PCN Date: 4/4/2013		Effective Date: 4/10/2013
Title: Adding test and shipping site, with different tape & reel material (lokreel, cover tape and carrier tape) for EM351		
Originator: KF Lee	Phone: 65 6511 6428	Dept: SM/QA
Customer Contact: Kathy Haggar	Phone: 1-512-532-5261	Dept: Sales
PCN Type: ☒ Datasheet ☐ Foundry ☒ Packing ☐ Product Revision ☐ Assembly ☐ Labeling ☐ Discontinuance ☒ Test ☐ Other		
Last Order Date: Not Applicable		
PCN Details		
Description of Change: Silicon Labs is adding ASE Chung Li, Taiwan (ASECL) as a test and shipping site for EM351 in addition to the current site; STATS Chippac Malaysia (SCM). As a result, Silicon Labs is required to use different packing materials (lokreel, cover tape & carrier tape) for EM351 as per the description below.		
	SCM	ASECL
Package	Carrier Tape part #	Carrier Tape part #
48QFN 7X7	R021-0700X	BD0700X0700J
	SCM	ASECL
Package	Lokreel part #	Lokreel part #

APPENDIX A (carrier tape comparison for 48QFN 7X7)

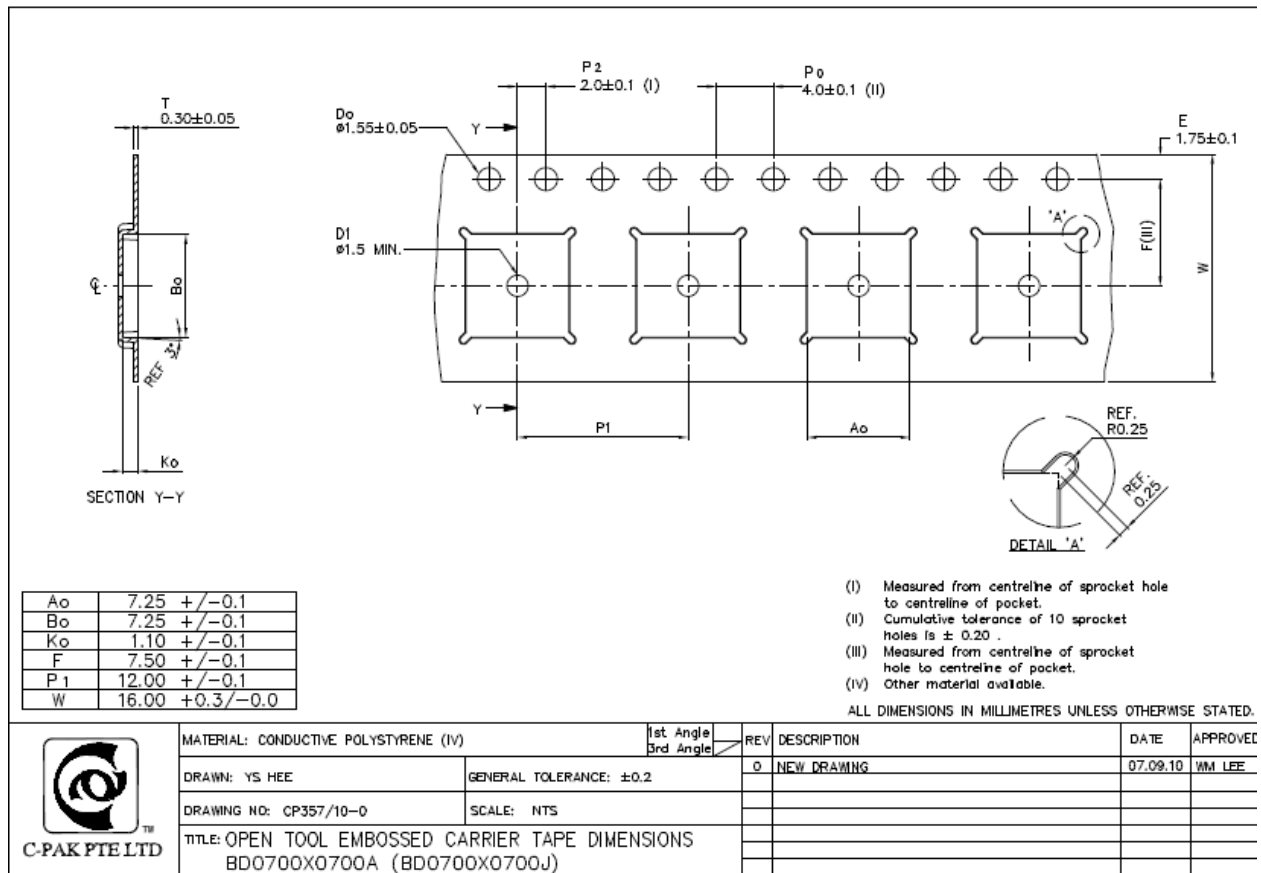
Critical dimension/package type	SCM	ASECL	Comparison Remarks
Material	Carrier Tape	Carrier Tape	
Vendor	Cpak	Cpak	
Part #	R021-0700X	BD0700X0700J	
Measurement Unit	MM	MM	MM
Carrier tape width	15.7 - 16.3	16.0 - 16.3	OK
Pocket pitch	11.9 - 12.1	11.9 - 12.1	OK
Rail hole pitch	3.9 - 4.1	3.9 - 4.1	OK
Pocket position to sprocket hole	7.4 - 7.6	7.4 - 7.6	OK
Sprocket hole diameter	1.5 - 1.6	1.5 - 1.6	OK
Ao	7.15 - 7.35	7.15 - 7.35	OK
Bo	7.15 - 7.35	7.15 - 7.35	OK
Ko	1.0 - 1.2	1.0 - 1.2	OK

APPENDIX B (cover tape comparison on 48QFN 7X7)

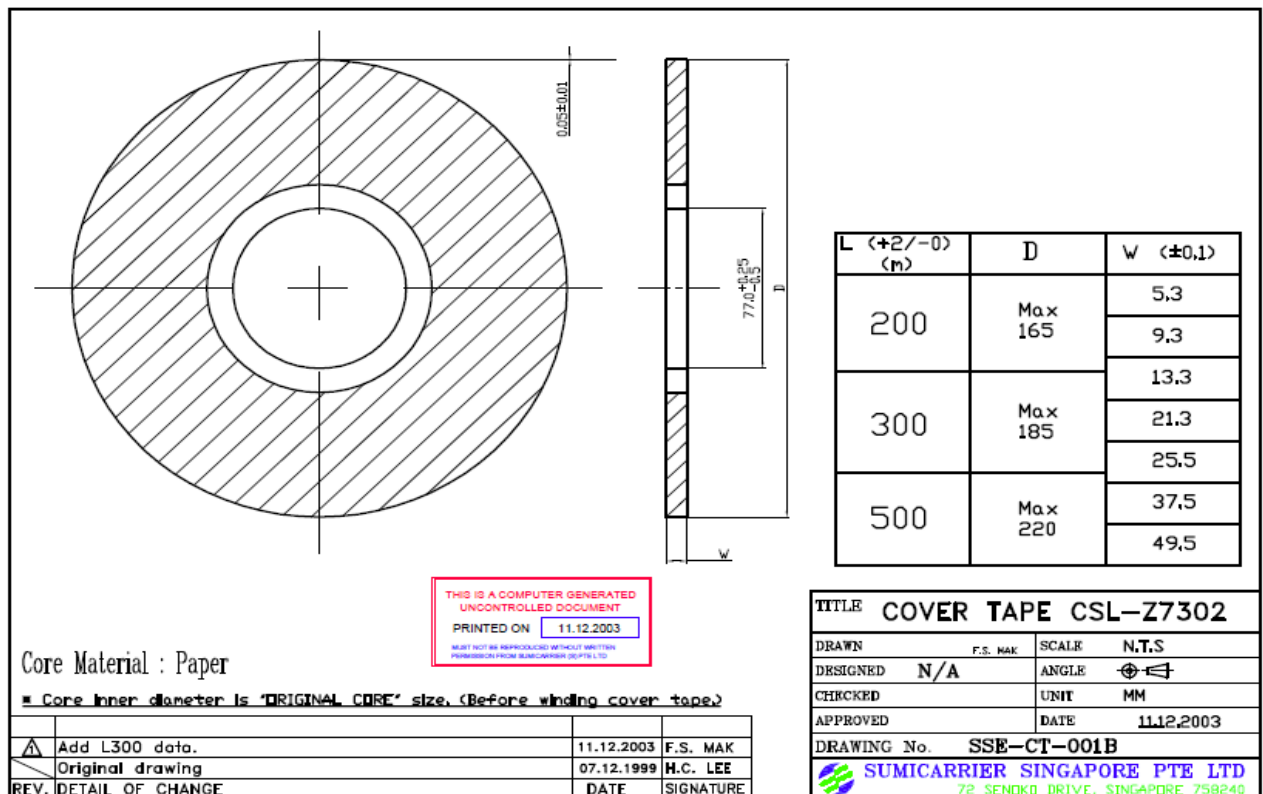
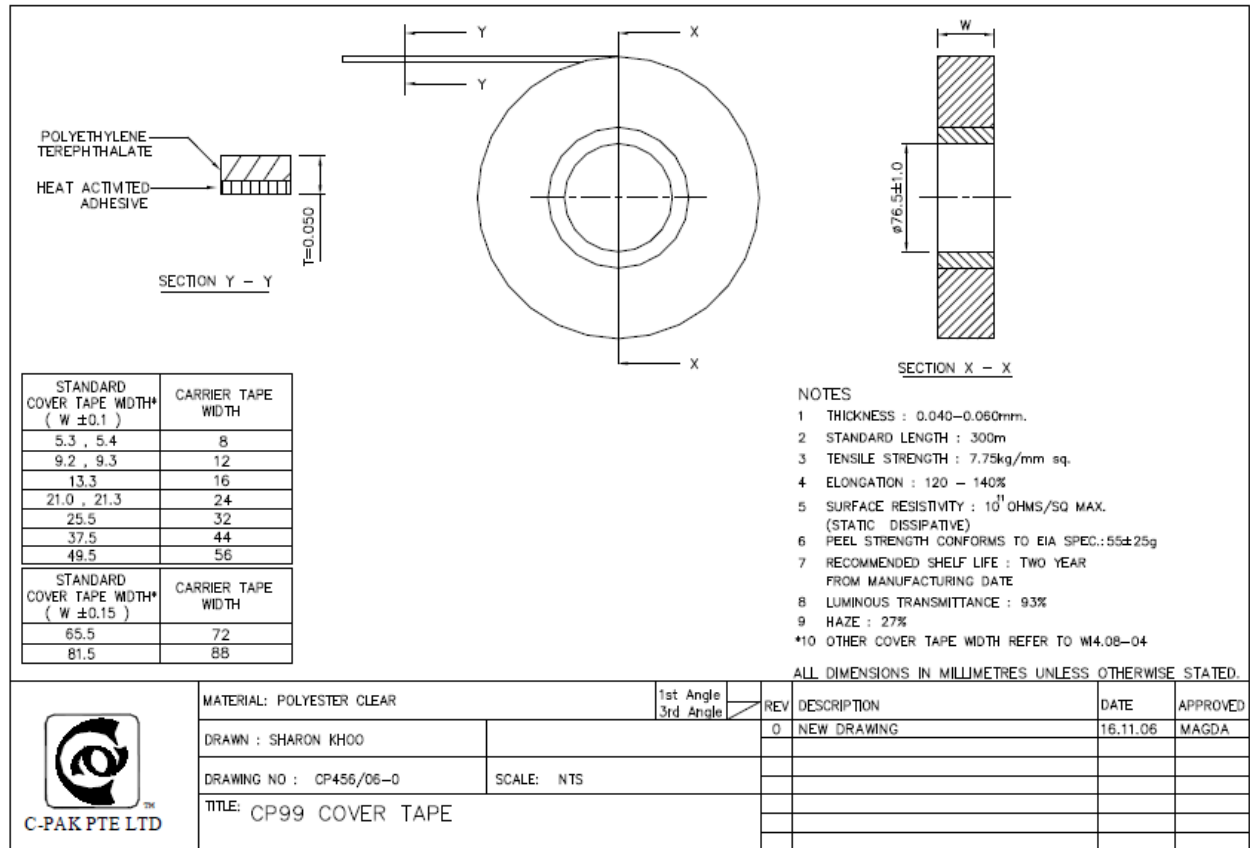
Critical dimension/package type	SCM	ASECL	Comparison Remarks
Material	Cover Tape	Cover Tape	
Vendor	Sumi Carrier	Cpak	
Part #	R021-0114B	CP99-133A	
Measurement Unit	MM	MM	MM
Width	13.2 - 13.4	13.2 - 13.4	OK
Length	302 Meter	300 Meter	OK
ESD Properties			
Surface Resistivity (Ohms / SQ)	10^{11}	10^{11}	OK

APPENDIX C (lokreel comparison on 48QFN 7X7)

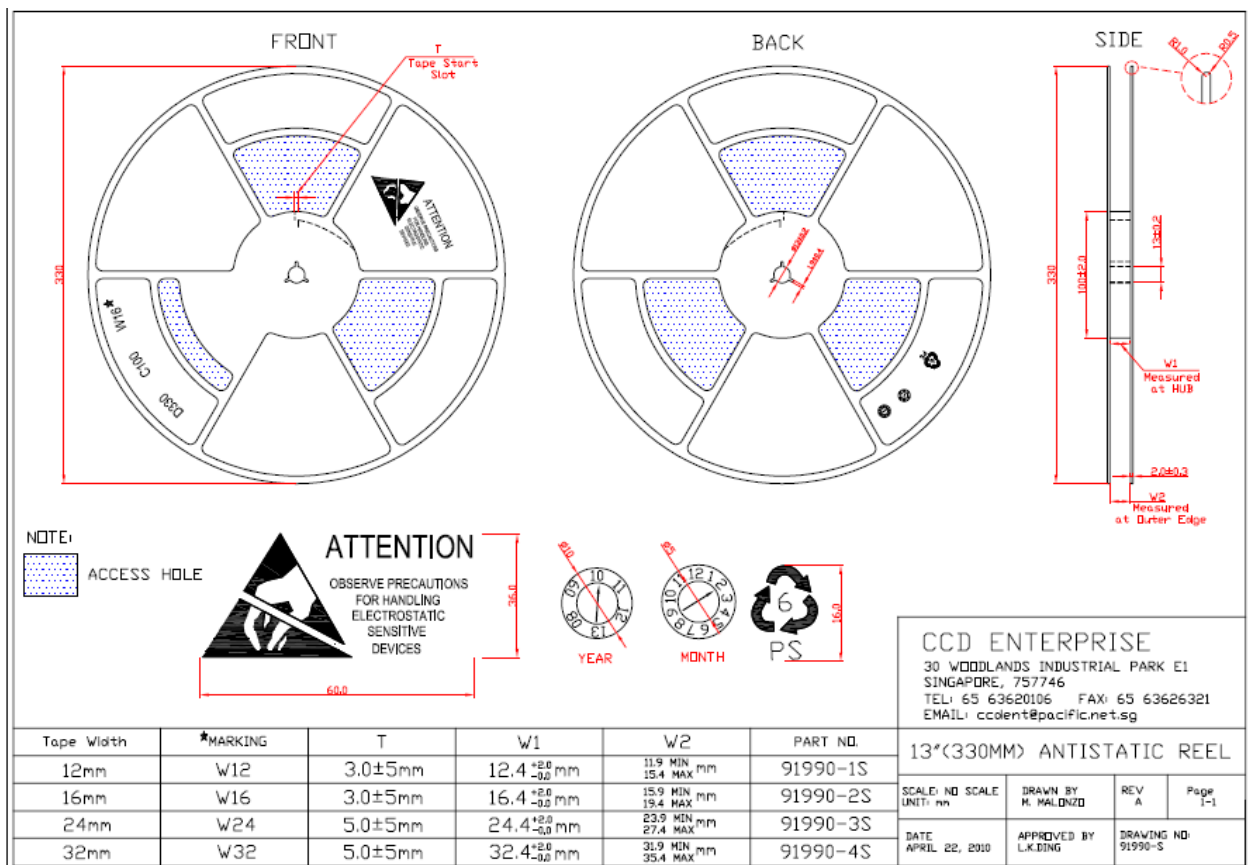
Critical dimension/package type	SCM	ASECL	Comparison Remarks
Material	Lock Reel	Lock Reel	
Vendor	CCD Enterprise	Cpak	
Part No	R021-1462X	43000051P1	
Measurement Unit	MM	MM	MM
Reel Hub Width (W1)	16.4 - 16.6	16.4 - 16.6	OK
Reel Outer Width (W2)	15.9 - 19.4	16 - 22.4	Difference 0.1 - 3 (meeting EIA 481 spec.)
ESD Properties			
Surface Resistivity (Ohms / SQ)	$10^6 - 10^{11}$	$10^6 - 10^{12}$	OK
